Service Bulletin

Bulletin No.: 24-NA-047

Subject: Interior Indented Door Panel

Brand:	Model:	Model Year:		VIN:		Engine:	Transmission:
		from	to	from	to		
Cadillac	Escalade	2022	2024				
	Escalade ESV

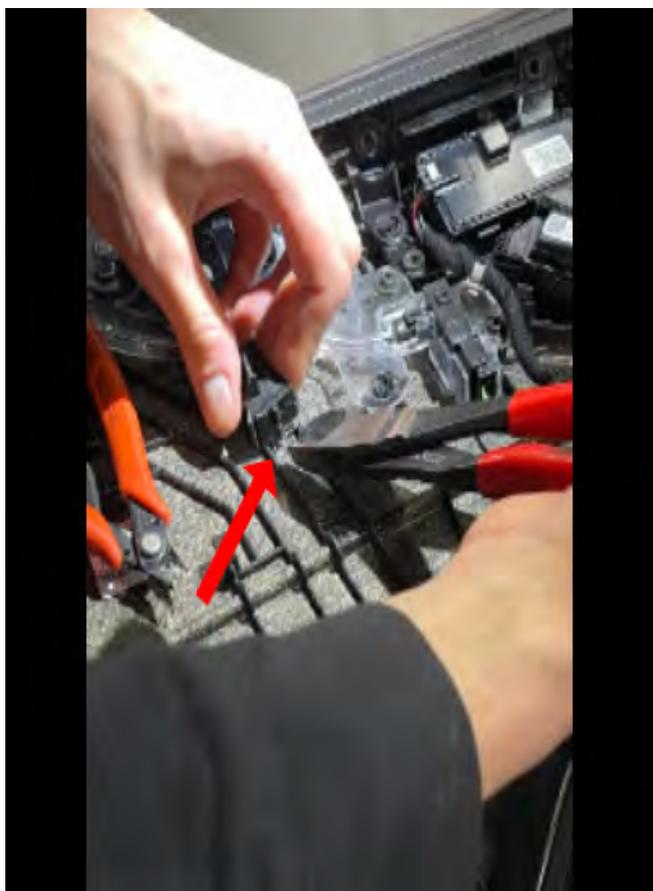
Involved Region or Country	North America, Europe, Kazakhstan, Uzbekistan, Russia, Middle East, Iraq, Israel, Palestine, Argentina (Mercosur), Brazil (Mercosur), Bolivia (West), Chile (West), Colombia (West), Ecuador (West), Paraguay (West), Peru (West), Uruguay (West), Venezuela (West), Other Central America, Japan, Cadillac Korea (South Korea), GM Korea Company, China - SGM, Taiwan , Thailand (ASEAN), Singapore, Phiippines, Australia/New Zealand, Caribbean, Egypt, Other Africa, South Africa
Additional Options (RPOs)	
Condition	<p>Some customers may comment on one or both front interior door panels have become permanently indented at the forward/upper section of the door panel.</p>  <p style="text-align: right;">6570306</p>
Note:	Example of door panel indentation. Damage can vary or be only slightly visible.
Cause	The cause of the condition may be the edge material from the bezel/bolster has excessive contact pressure against the door panel retention clip when doors are closed.

Correction	Replace the door panel and grind down the door panel retention clip. Important: Refer to the Electronic Parts Catalog (EPC) for the proper color door panel.

2. Place the new door panel on a suitable table to remove the door retention clip.

3. Using a cutting tool cut off the door retention clip block.

Note: It's best to use a hand cutting tool and start at the center of the block then cut around the edges.

4. Then using a grind tool, smooth out the door panel.

- Once the retention clip is smooth then replace the door panel.
